REACTIVITY CONTROL SYSTEMS

SHUTDOWN MARGIN - K_{N-1} - ANY CEA WITHDRAWN

8911150089 891106
PDR ADOCK 05000529
P PDC

FIGURE 3.1- 1A

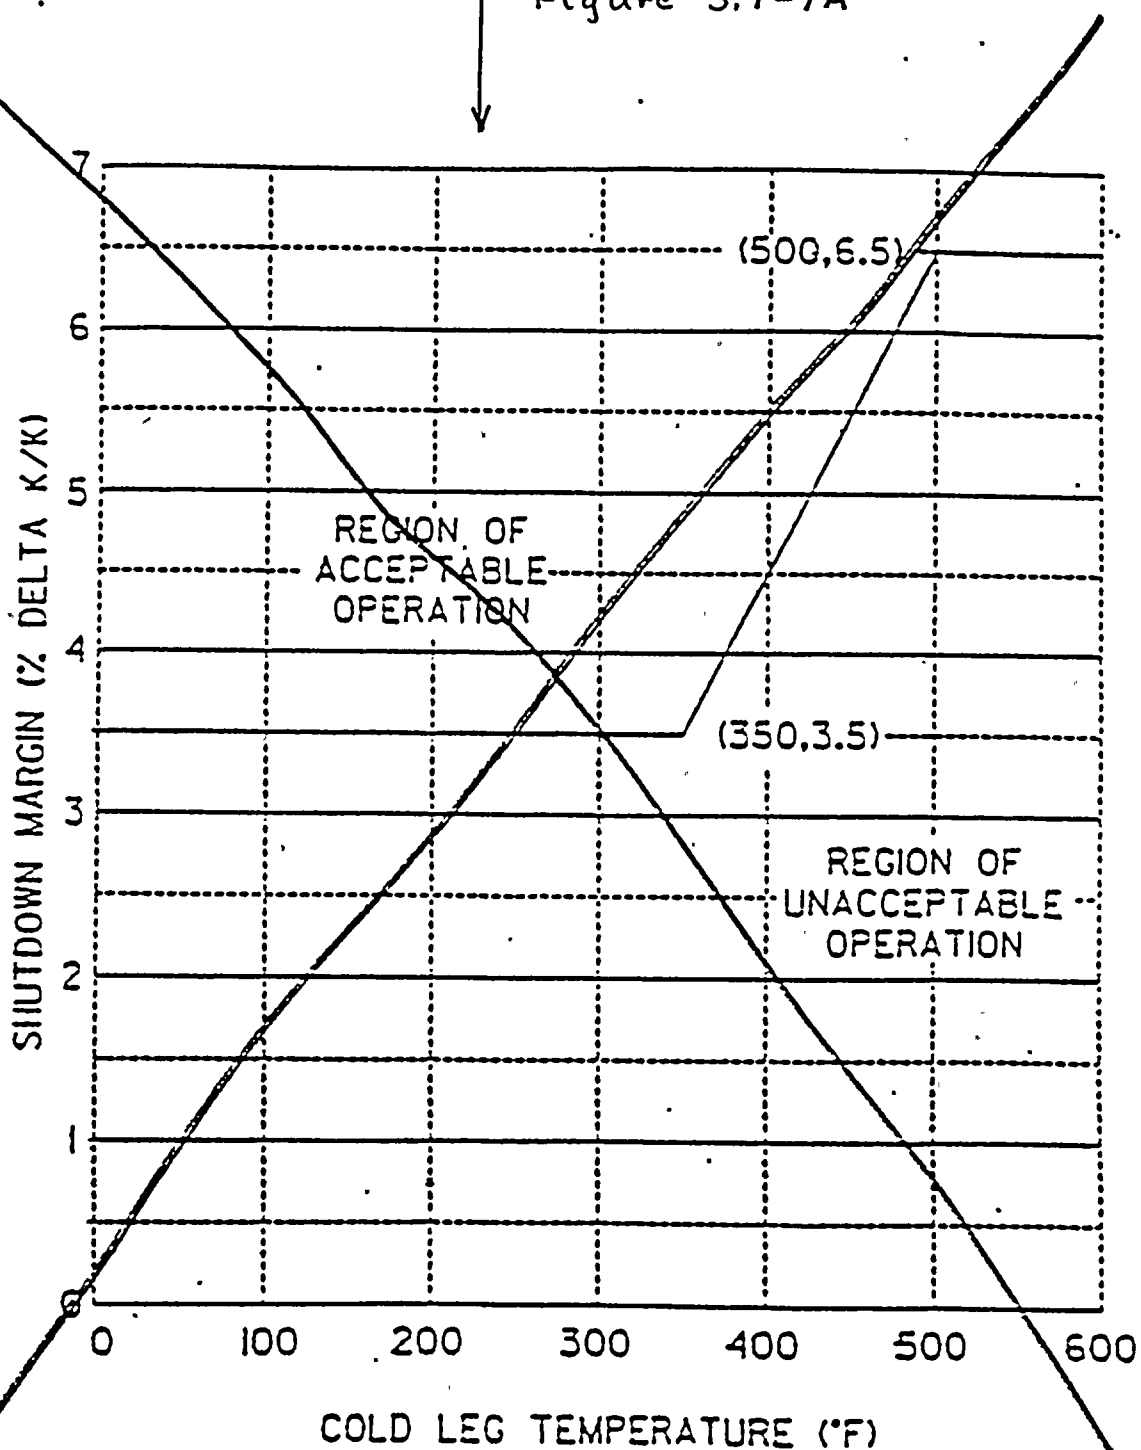
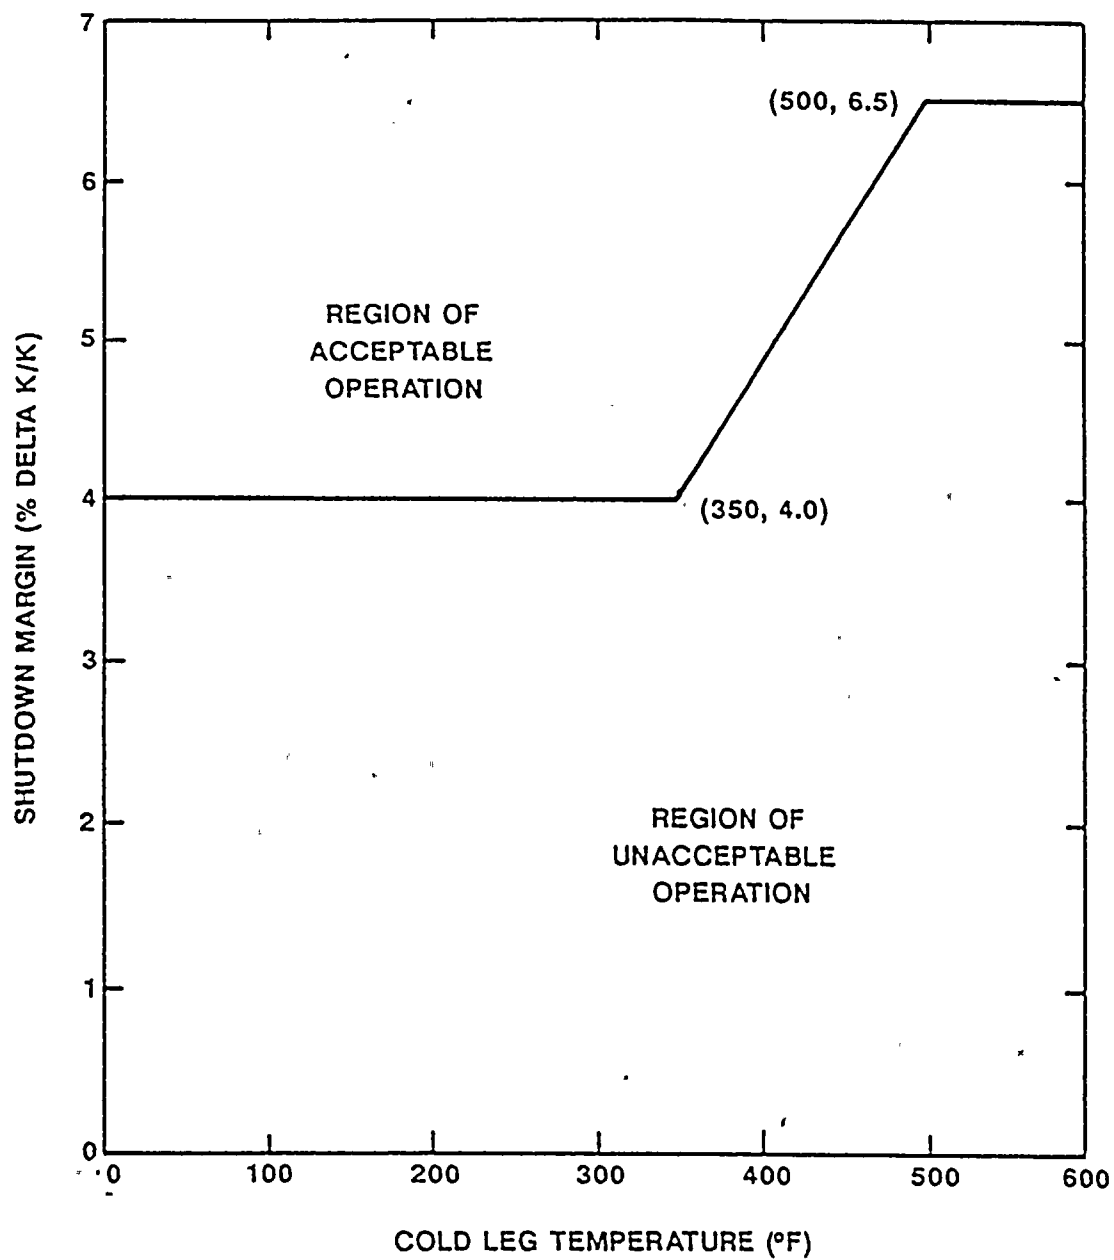
Replace with New
Figure 3.1-1A

REVISED
FIGURE

FIGURE 3.2-2

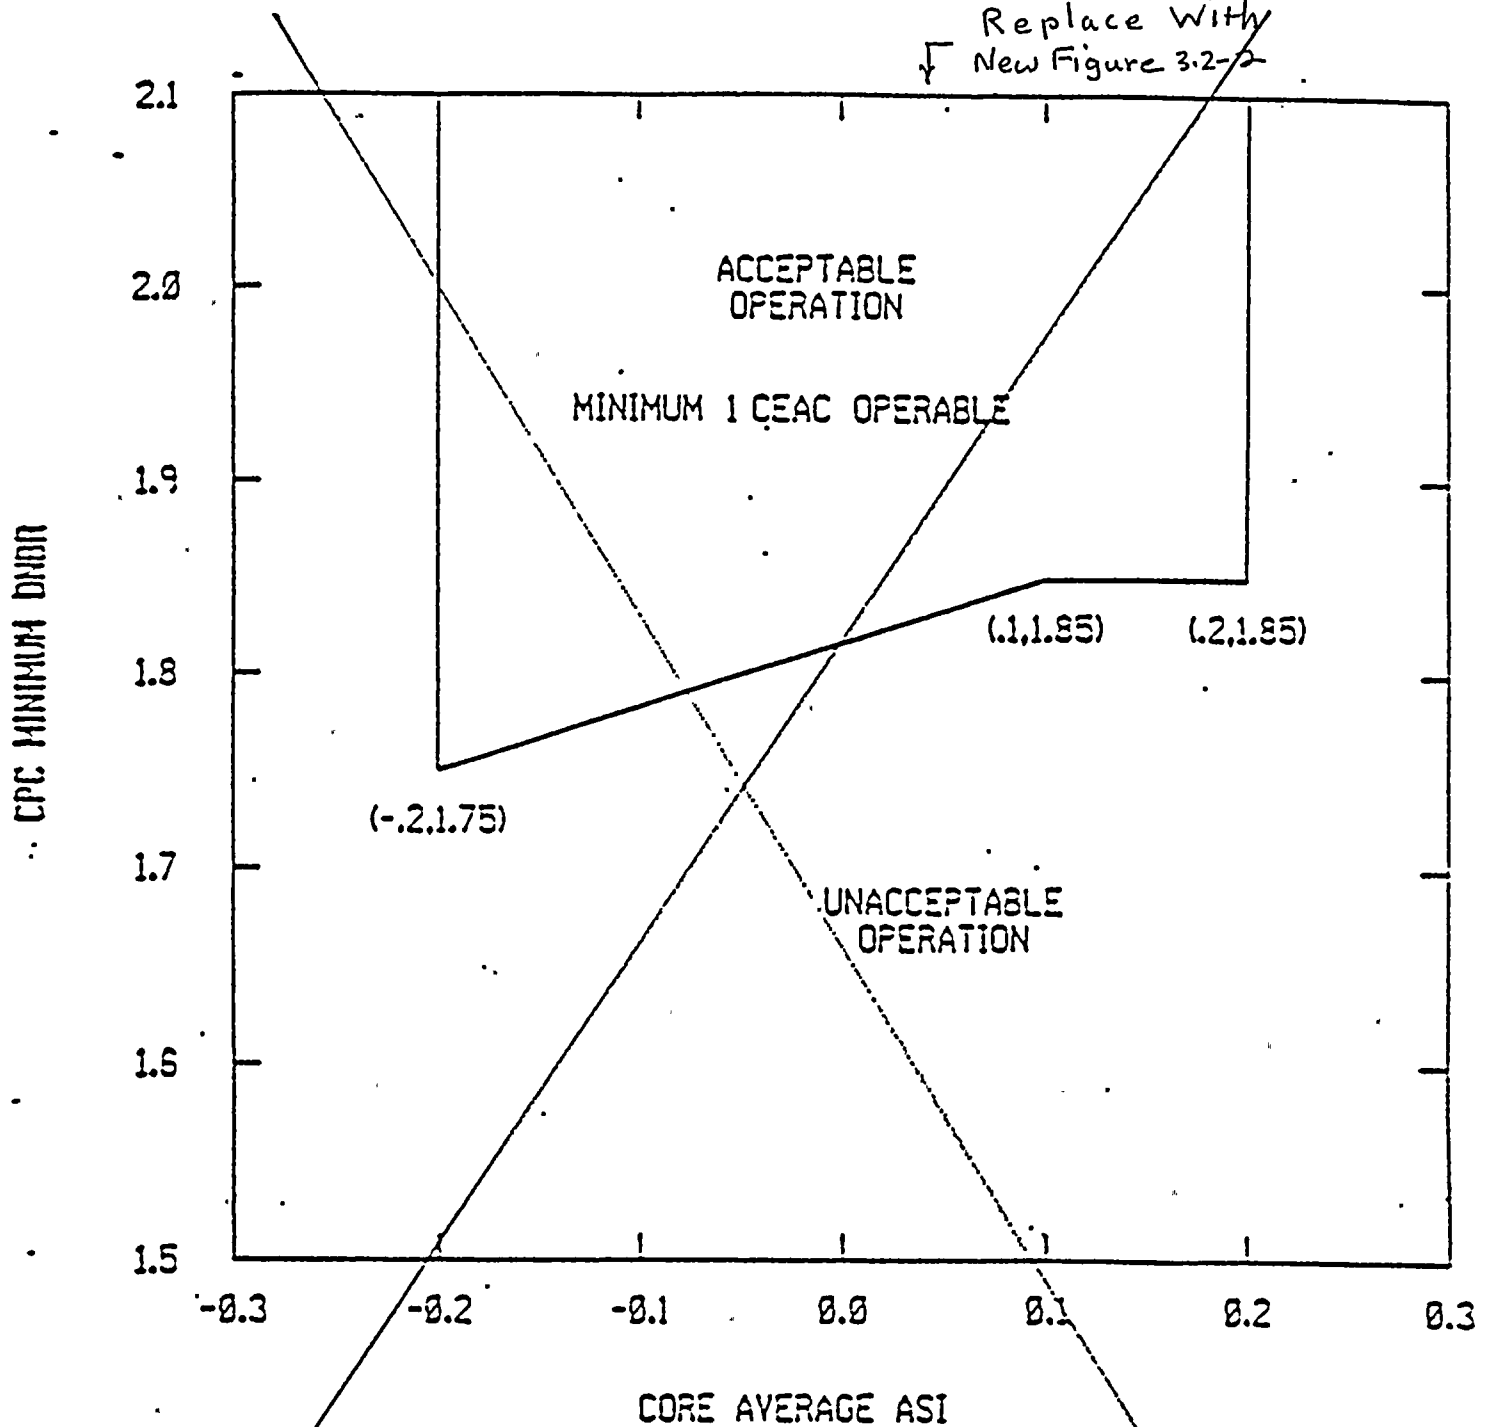
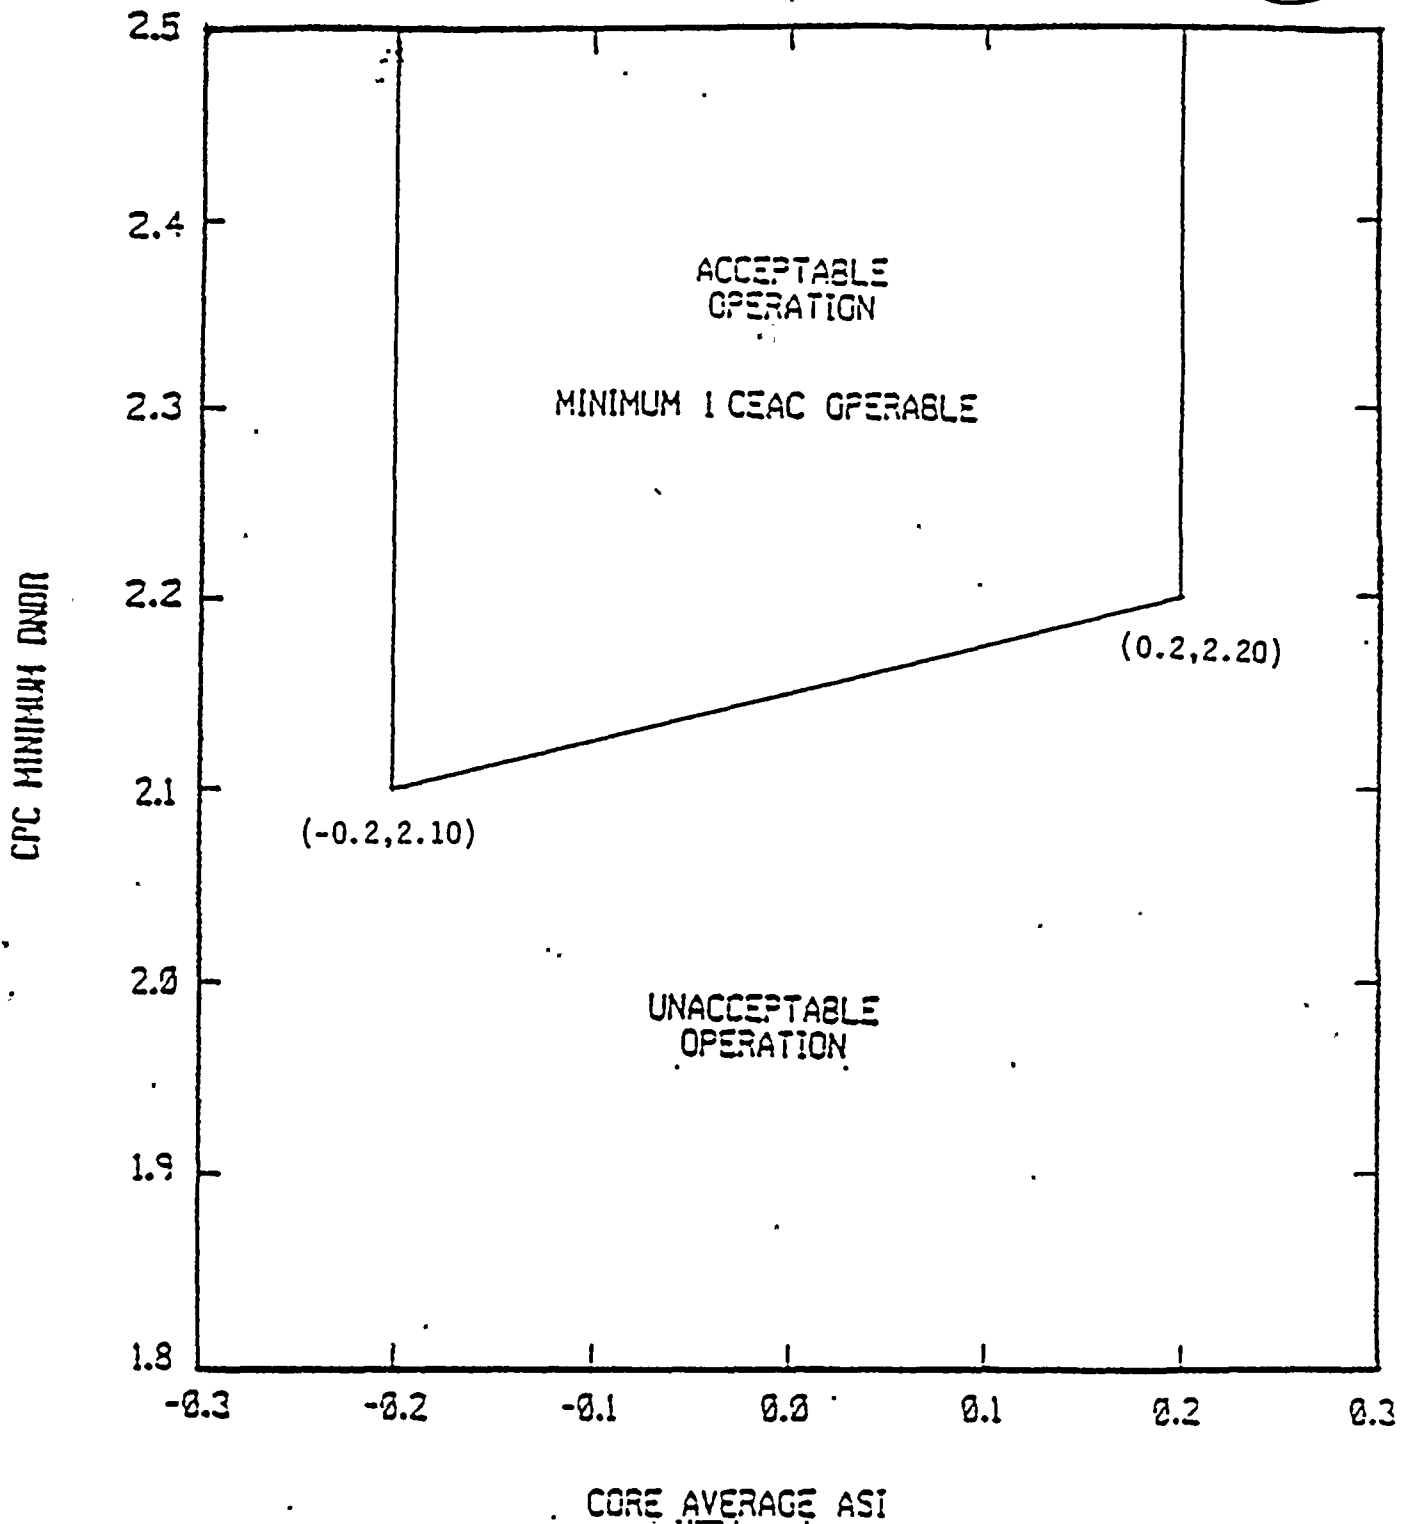
Replace with
New Figure 3.2-2

Revised
Figure

FIGURE 3.1-3

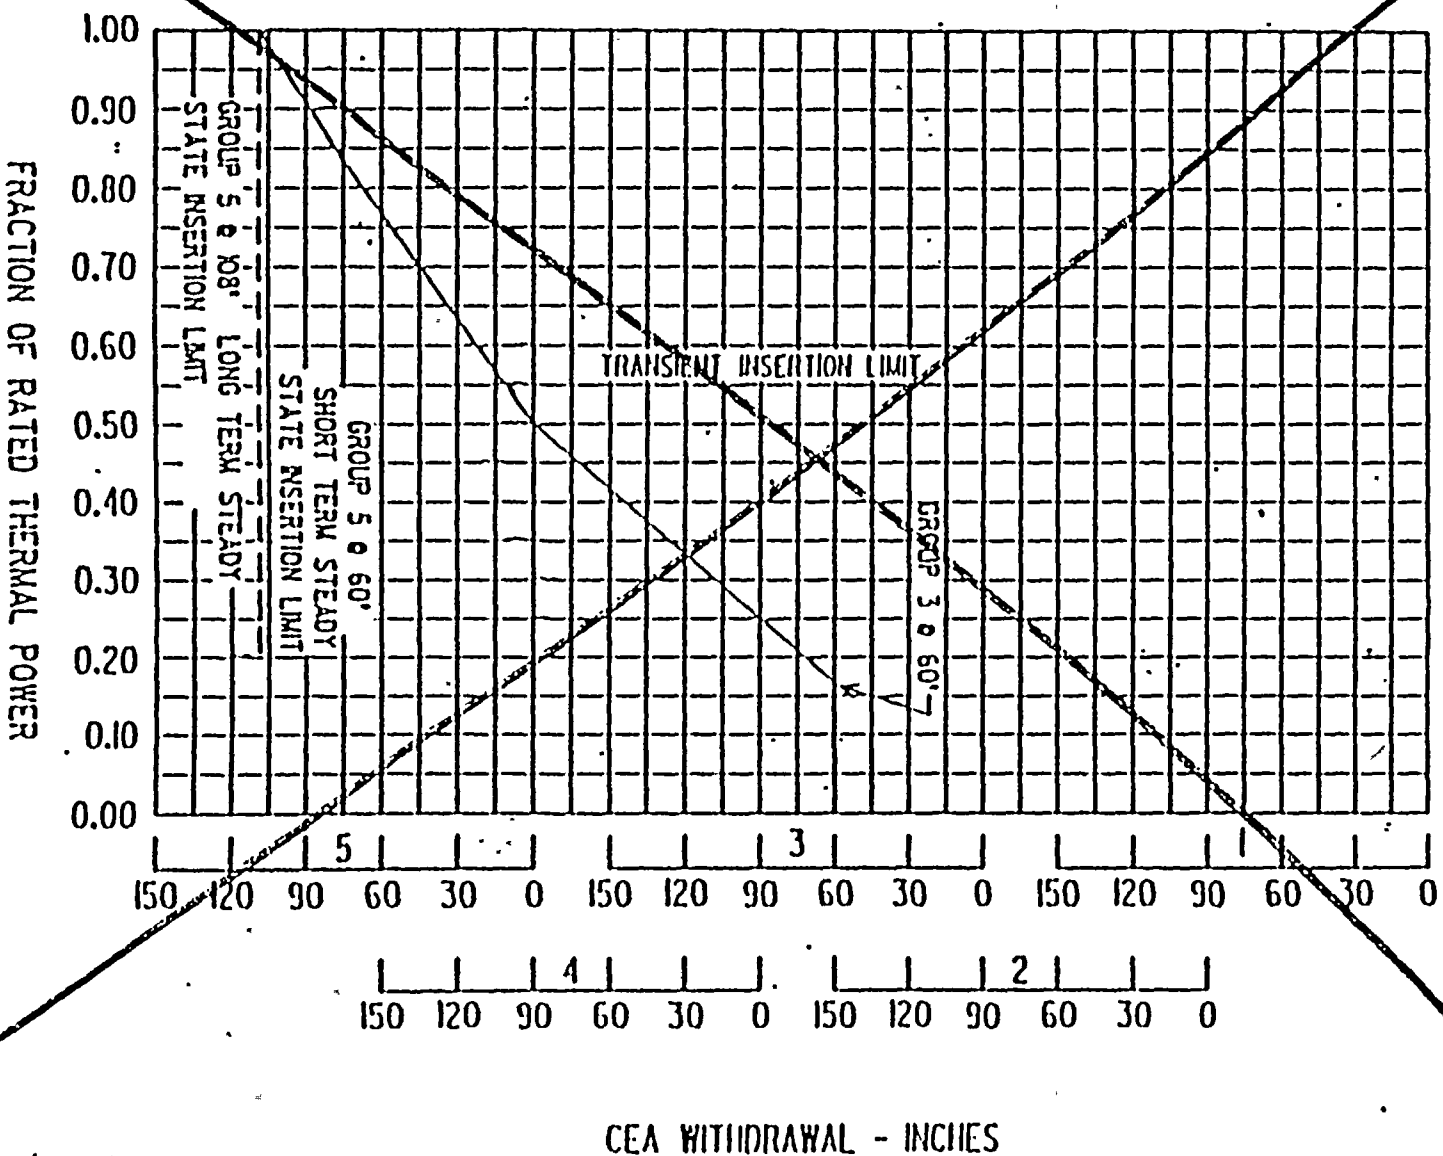
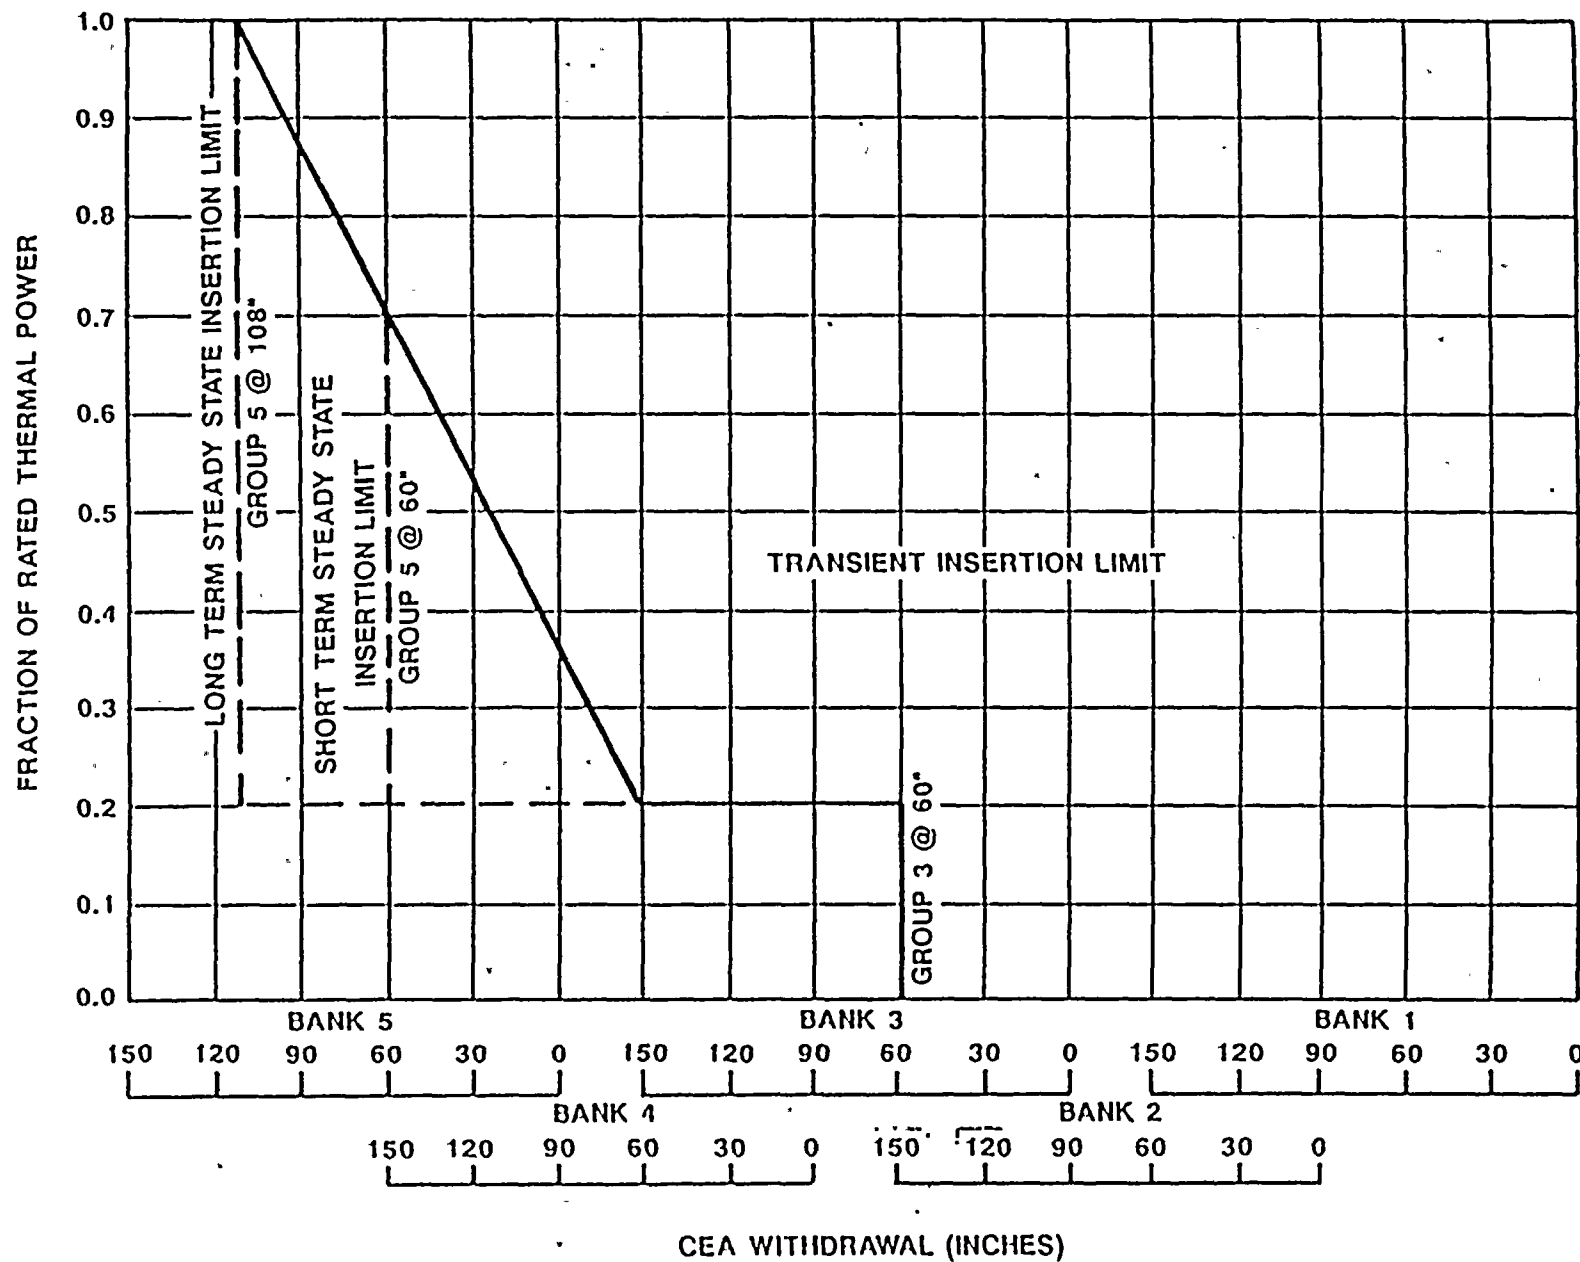
Replace with New

Figure 3.1-3
